**CHARLES M. HINTON, JR. REGIONAL LANDFILL  
DALLAS COUNTY, TEXAS  
TCEQ PERMIT NO. MSW-1895A**

**PERMIT MODIFICATION**

**MONITORING WELL SPACING REVISION**

Re: Permit Modification Application  
Monitoring Well Spacing Revision  
Charles M. Hinton Jr. Regional Landfill, MSW Permit No. 1895A  
Dallas County, Texas  
Tracking No. 11994764; RN103049490/CN600328694

FIGURE 10

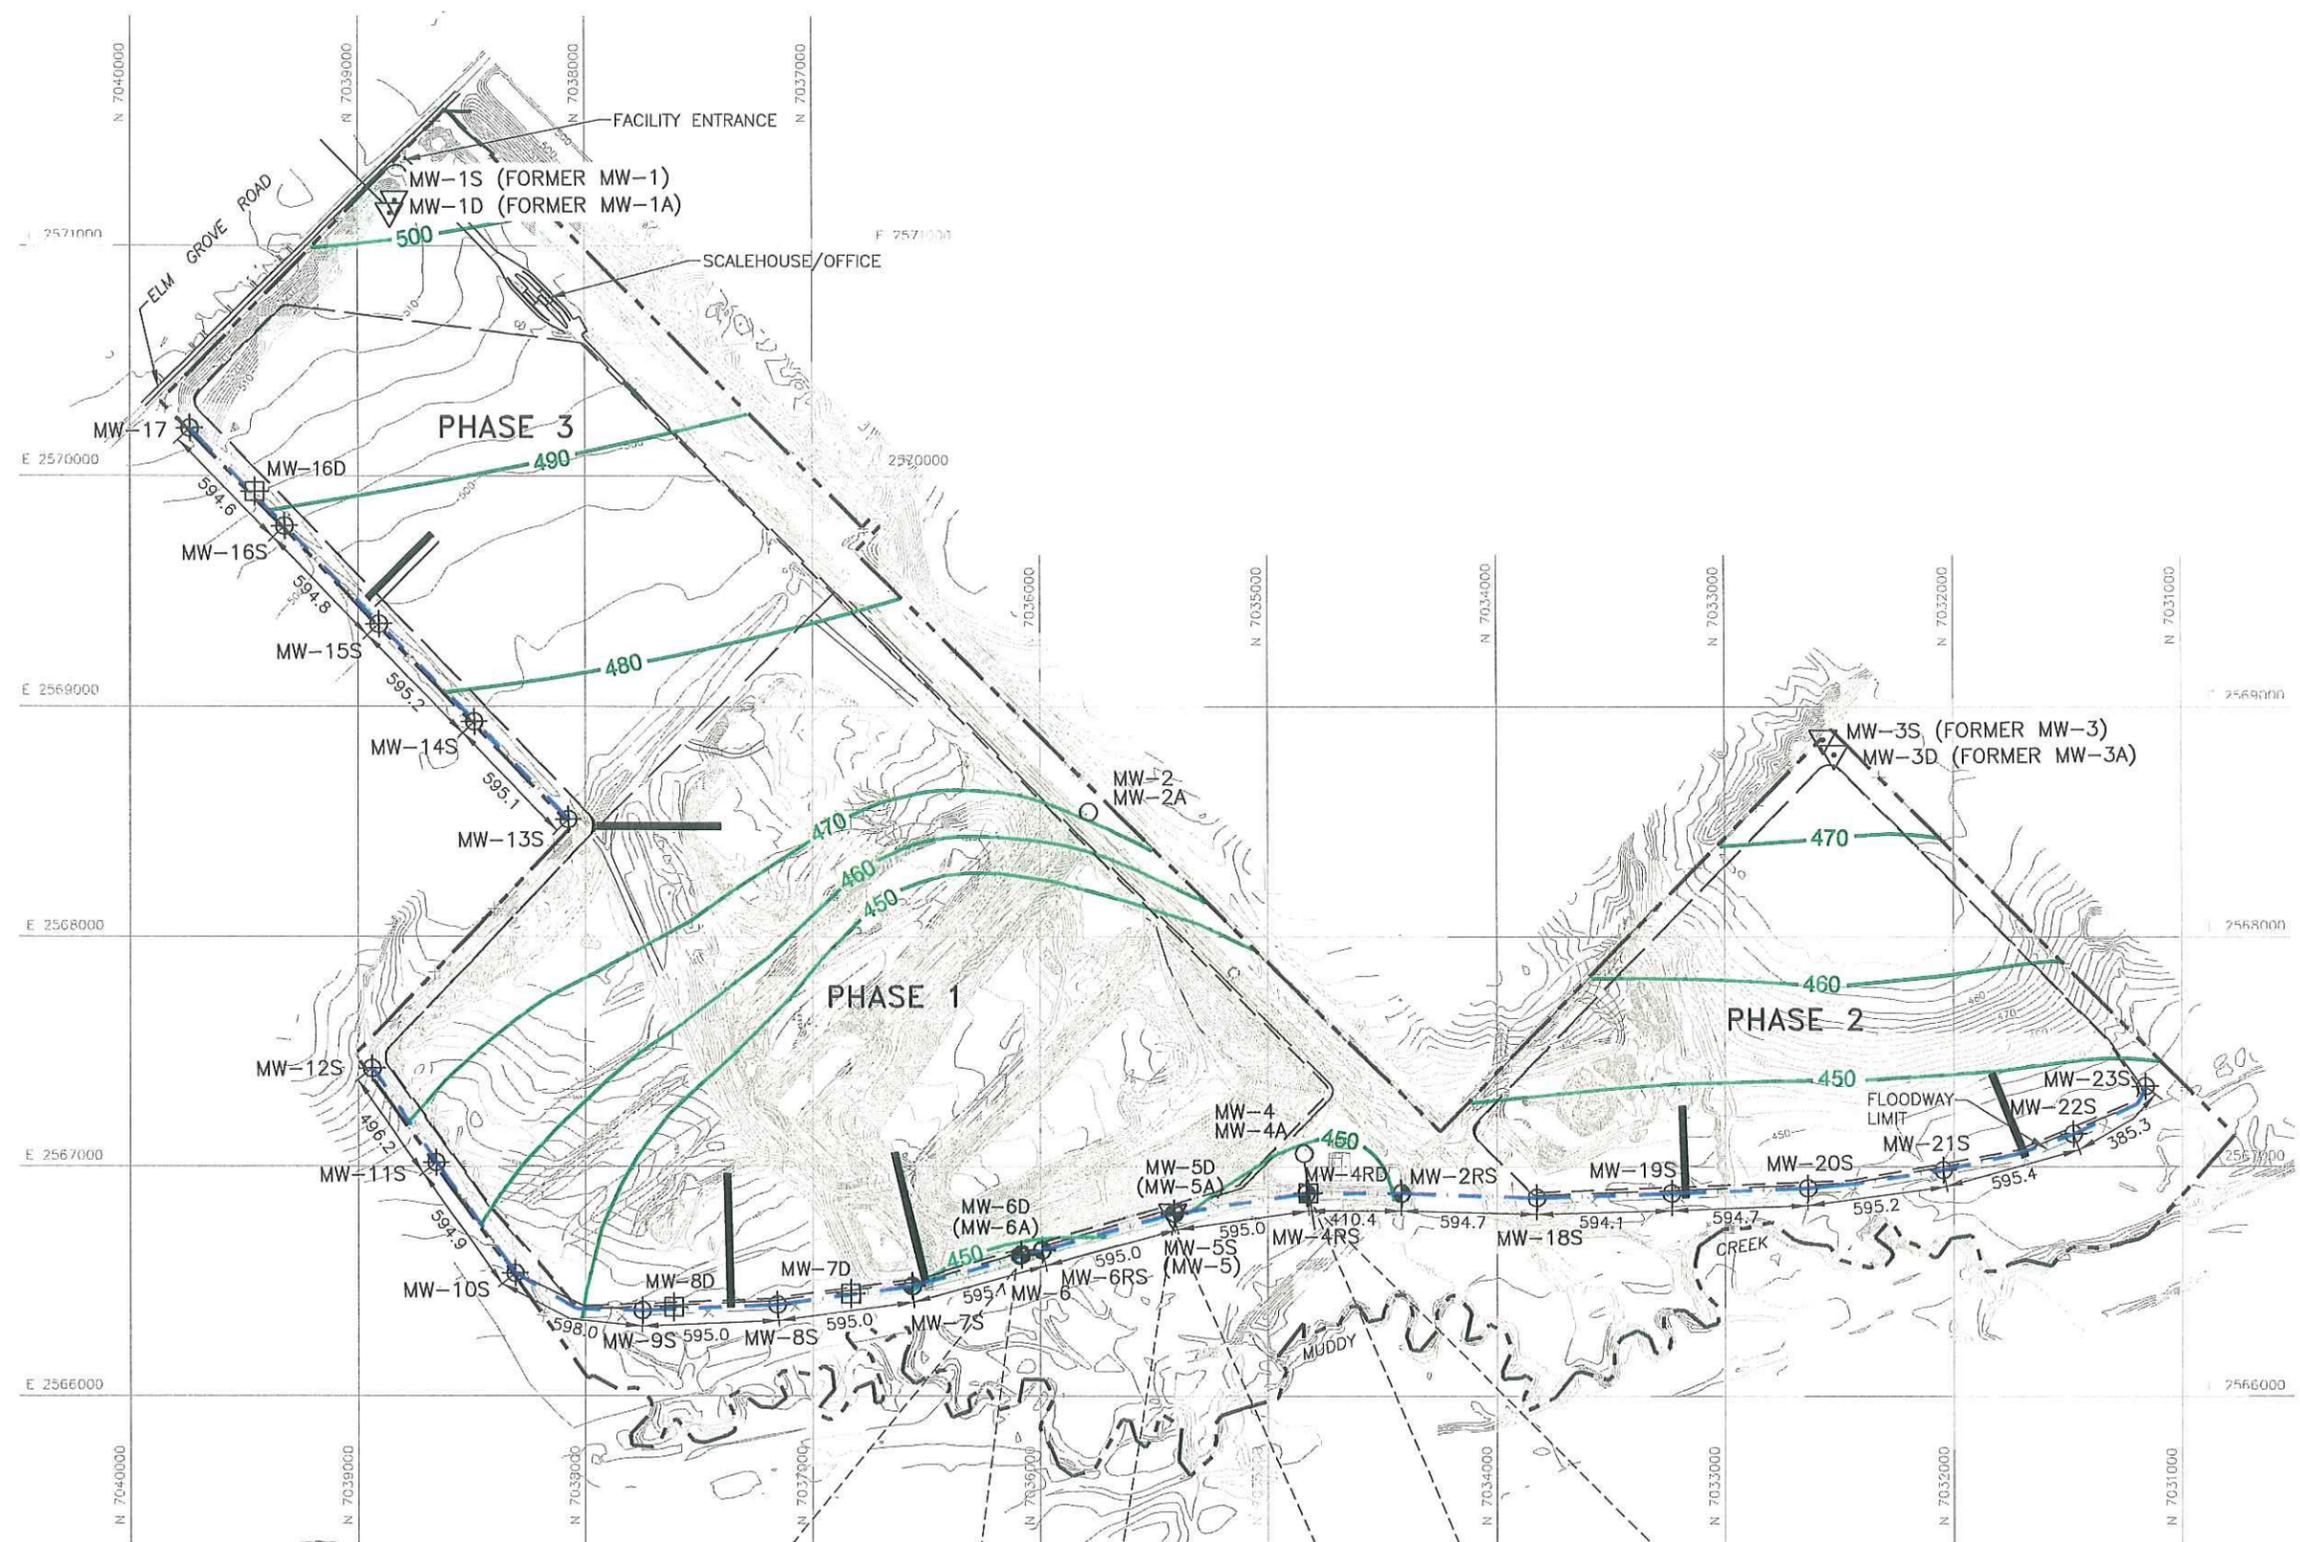
Replacement or Additional Page/Section Number	Explanation
Attachment 5 – Appendix A, Figure 10	Former Figure 10 – Proposed Groundwater Monitoring System replaced with proposed Figure 10 to reflect revised groundwater monitoring system layout.
Attachment 5 – Appendix A, Figure 11	Former HDR Figure 11 – Typical Monitor Well Detail drawing is replaced with proposed Figure 11 – Typical Monitoring Well Details to illustrate proposed typical monitoring well construction details.
Attachment 5 – Appendix A, Figure 12	Former monitor well details table on pages 25 and 26 removed and replaced by Attachment 5's Appendix A, Figure 12 – More Monitoring Well Details to reflect revised groundwater monitoring well details.
Attachment 5 – Appendix 2 Groundwater Monitoring System Certification	Revised page has been signed and sealed for updated SDP.

As shown on Attachment 5 Figures 10 and 12, the proposed monitoring system will consist of 31 monitoring wells when the landfill is fully developed. Four existing background detection monitoring wells (MW-1, MW-1A, MW-3 and MW-3A) are designated background well pairs in the proposed system. With the approval of this permit modification, these four wells will be renamed MW-1S, MW-1D, MW-3S, and MW-3D, respectively. The 'S' in the well name indicates the well is screened in a shallower portion of the uppermost aquifer and the 'D' indicates the well is screened in a deeper portion of the uppermost aquifer. One existing background well pair (MW-2 and MW-2A) will be removed at the time of new well installations – as only two sets of background wells are needed for statistical evaluation purposes.
